Project	<b>IEEE 802.16 Broadband Wireless Access Working Group</b> < <a href="http://ieee802.org/16">http://ieee802.org/16</a> >	
Title	<b>Action Items from Session #52 concerning sections 6.4.2.2 and 6.4.2.3</b>	
Date Submitted	<b>2008-01-15</b>	
Source(s)	Paul Piggin NextWave Wireless Unit 7 Greenways Business Park Bellinger Close Chippenham, Wiltshire SN15 1BN, UK.	Voice: 44 1249 800 100 Fax: 44 1249 800 101 ppiggin @ nextwave.com
Re:	Letter Ballot #29 of IEEE P802.16h/D3.	
Abstract	The author was assigned a number of action items during the resolution of comments as part of Letter Ballot #29. This contribution addresses these action items.	
Purpose	Resolution of comments from Letter Ballot #29 based on draft IEEE P802.16h/D3.	
Notice	<i>This document does not represent the agreed views of the IEEE 802.16 Working Group or any of its subgroups. It represents only the views of the participants listed in the "Source(s)" field above. It is offered as a basis for discussion. It is not binding on the contributor(s), who reserve(s) the right to add, amend or withdraw material contained herein.</i>

## Action items from Session #52 concerning sections 6.4.2.2 and 6.4.2.3

***[Comment 38] [Comment 39] Replace figure h1 page 27 line 62 in [1] with the following.***

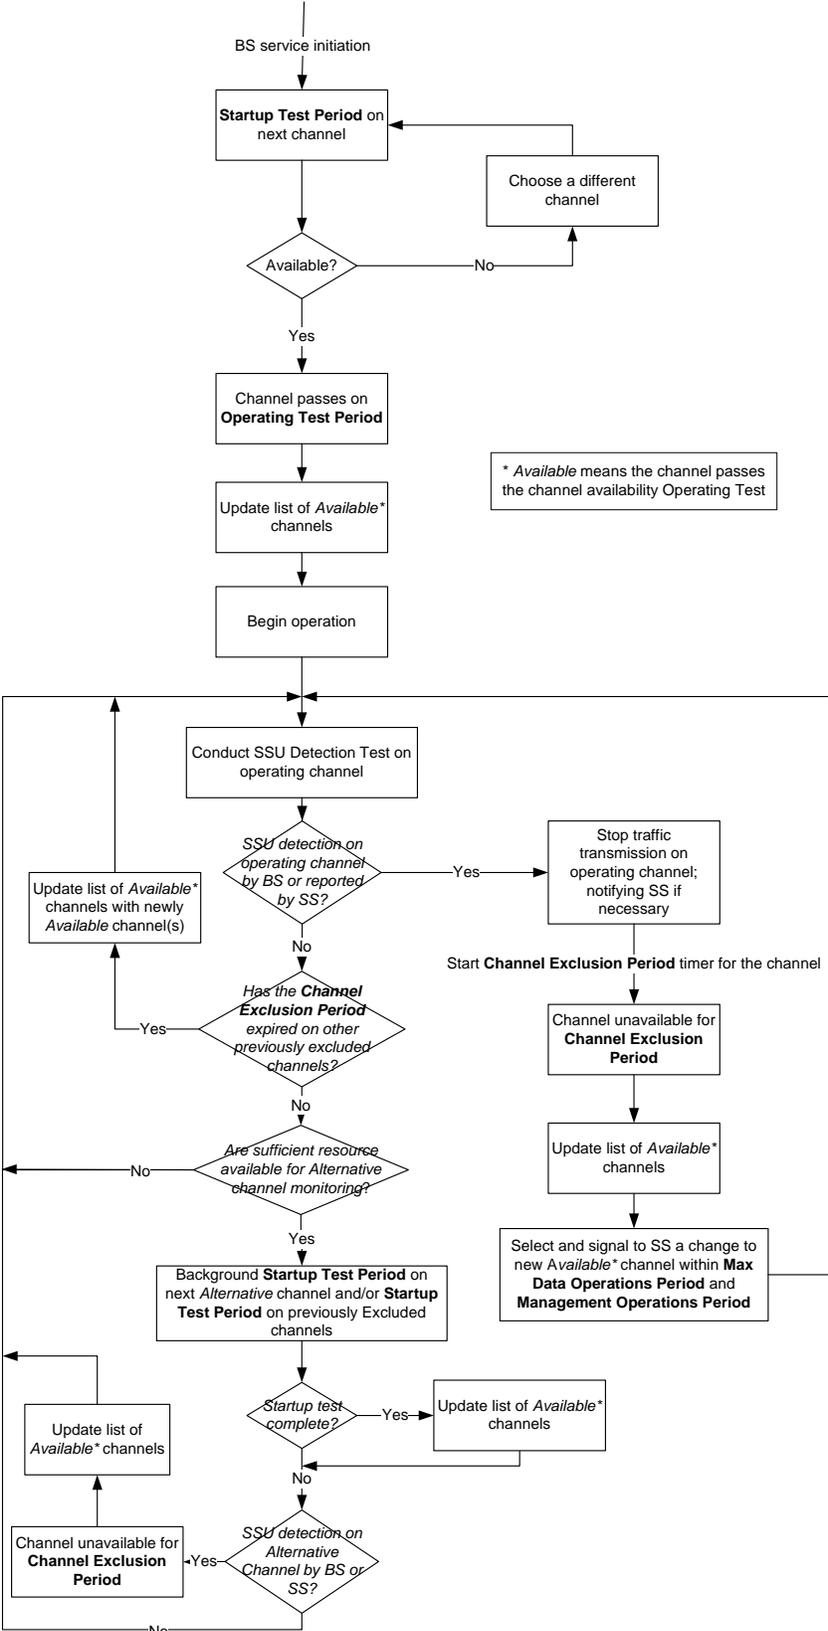
*Comment 38: If "Stop transmission on channel" here, then can't notify the next working channel to SS.*

*Comment 39: It is not clear what it is meant by "Are air interference monitoring resource available ?" in the diamond box*

Adding revised figure h1 in section 3 with tag [Comment38].

Adding revised figure h1 in section 3 with tag [Comment39].

[Comment 40] [Comment 41] Replace figure h2 page 28 line 54 in [1] with the following.

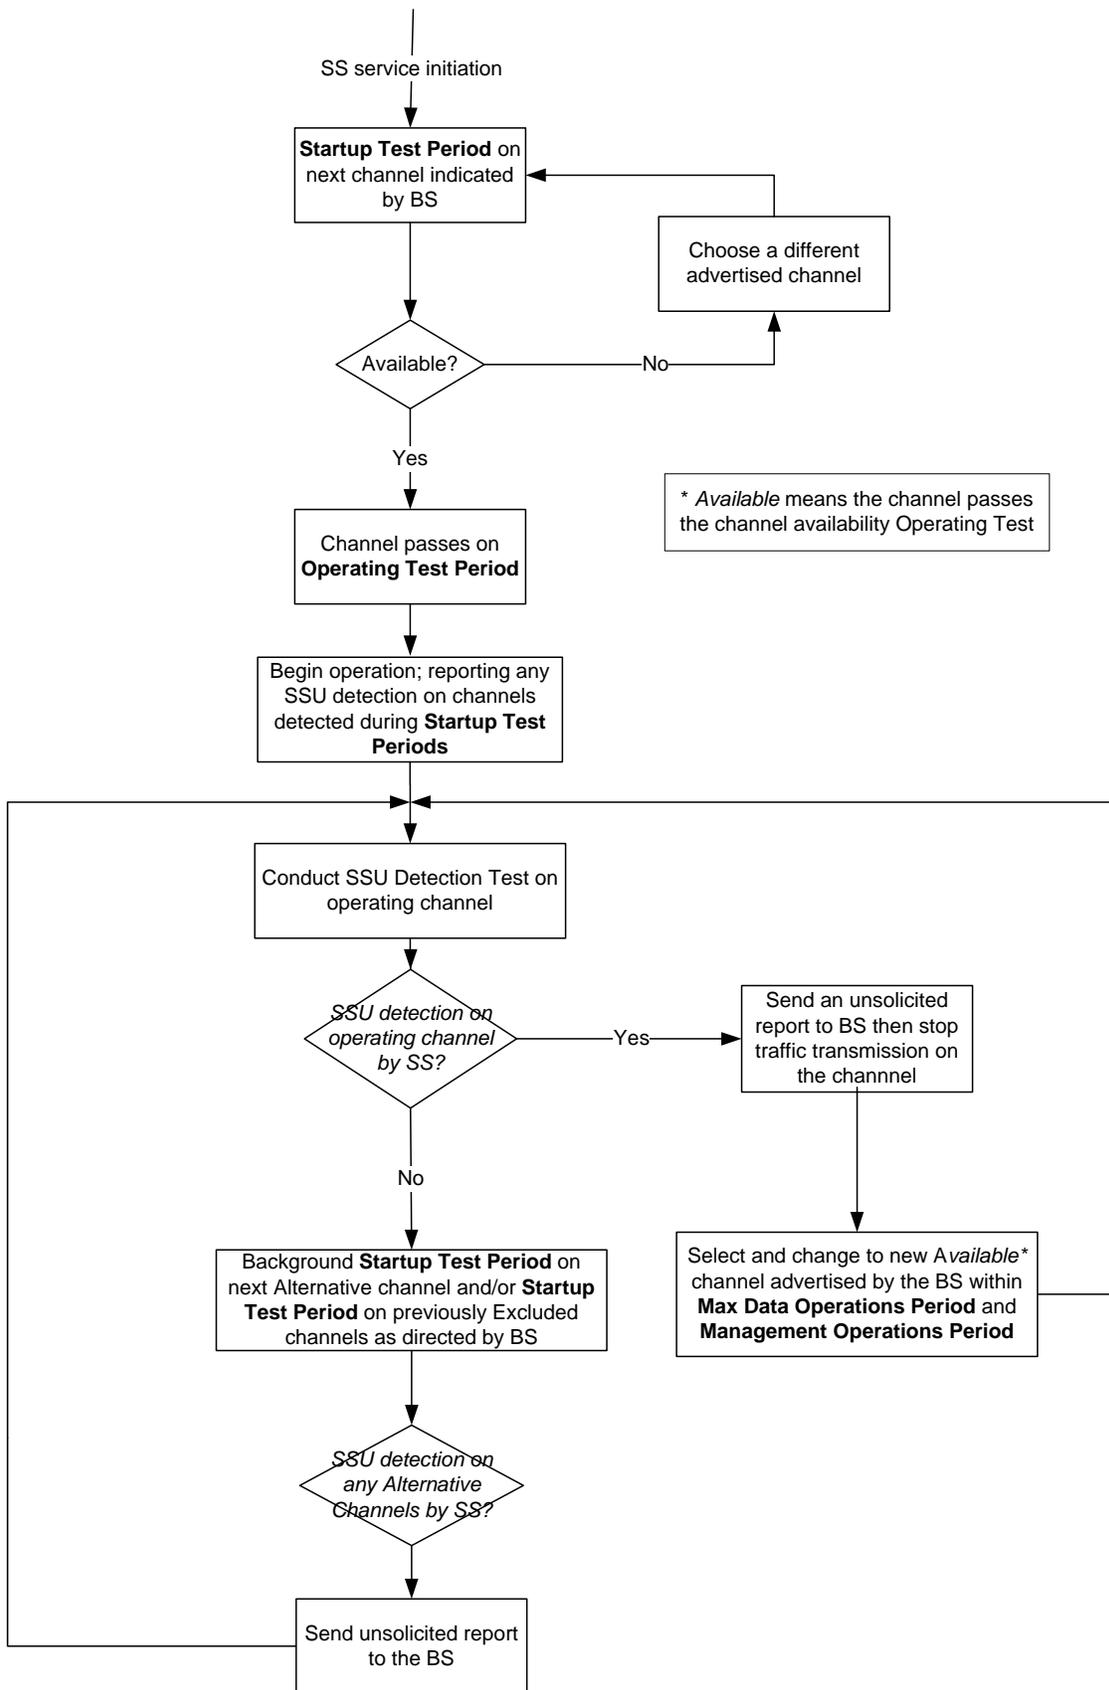
*Comment 40: "If the channel is not available, SS choose a different advertised channel to text". If the channel is not available, SS shall report BS first and may wait for further instruction from BS or may check another channel. Otherwise, BS may not know this channel has SSU.*

*Comment 41: "Stop transmission on channel and send unsolicited report to BS". If stop transmission on channel, then SS can't send report to BS.*

Adding revised figure h2 in section 3 with tag [Comment40].

Adding revised figure h2 in section 3 with tag [Comment41].

*[Comment 50] Replace figure h4 page 31 line 65 in [1] with the following.*

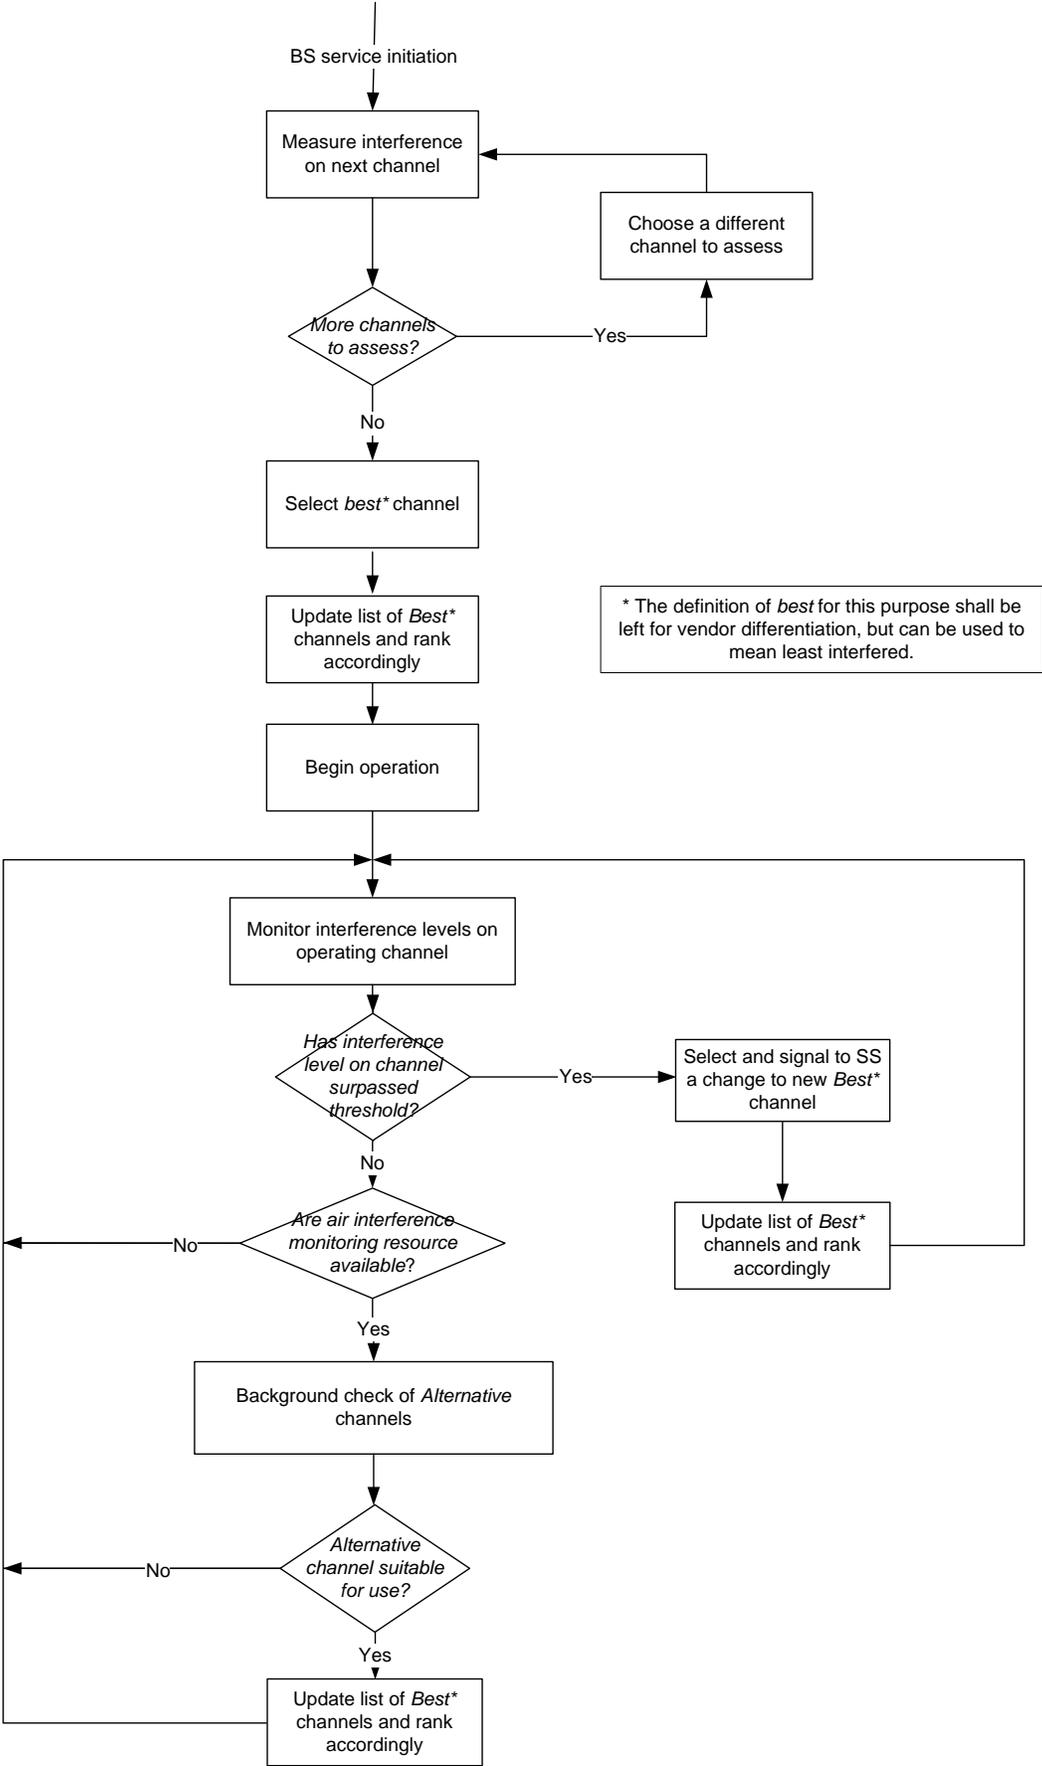
*Comment 50: What is the difference between 'alternative' and 'back up' channels?*

Adding revised figures h4 and h5 in section 3 with tag [Comment50].
